Project	IEEE 802.16 Broadband Wireless Access Working Group < http://ieee802.org/16 >	
Title	Comments on AWD 15.3.3 Frame structure	
Date Submitted	2009-04-24	
Source(s)	Yih-Guang Jan, Yang-Han Lee, Hsien-Wei Tseng, Ming-Hsueh Chuang Tamkang University (TKU)	yihjan@yahoo.com
	Youn-Tai Lee, Chun-Yen Hsu Institute for Information Industry (III)	lyt@nmi.iii.org.tw
	Shiann-Tsong Sheu National Central University (NCU)	stsheu@ce.ncu.edu.tw
	Whai-En Chen National Ilan University (NIU)	wechen@niu.edu.tw
Re:	Category: AWD comments / Area: Chapter 15.3.3 (Frame structure) “Comments on AWD 15.3.3 Frame structure”	
Abstract	Comments on AWD 15.3.3 Frame structure	
Purpose	To be discussed and adopted by TGM for the 802.16m AWD.	
Notice	<i>This document does not represent the agreed views of the IEEE 802.16 Working Group or any of its subgroups. It represents only the views of the participants listed in the “Source(s)” field above. It is offered as a basis for discussion. It is not binding on the contributor(s), who reserve(s) the right to add, amend or withdraw material contained herein.</i>

Comments on AWD 15.3.3 Frame structure

15.3.3.2.1.1 H-FDD frame structure

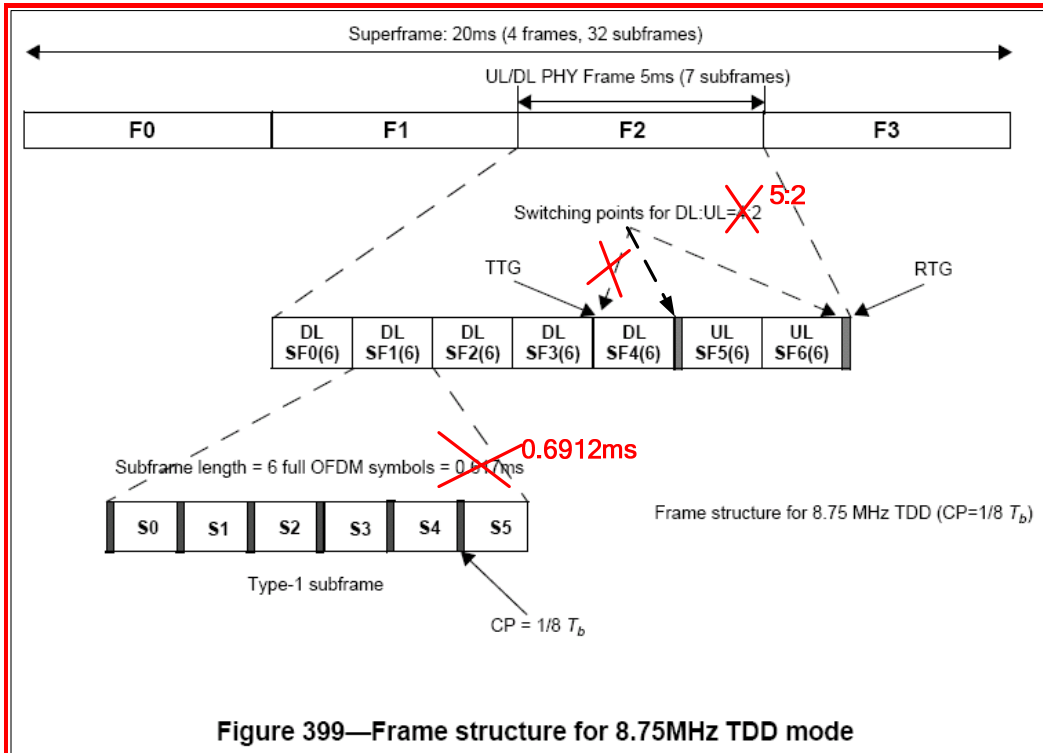
This contribution provides the corrected AWD text proposal to Frame Structure. In Figure 396, Figure 399, Figure 400, Figure 401, Figure 402 have some errors and correct the figures.

Figure 401—7 MHz TDD and FDD frame structure

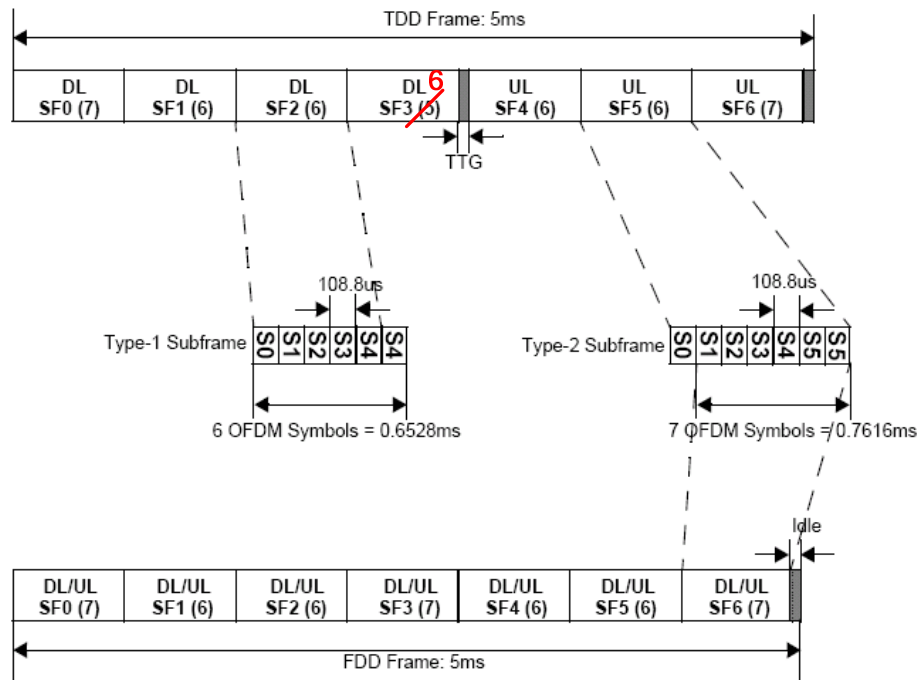
TDD and FDD frame structure for 7MHz channel with a CP of $1/16 T_b$ (DL to UL ratio of 4:2).
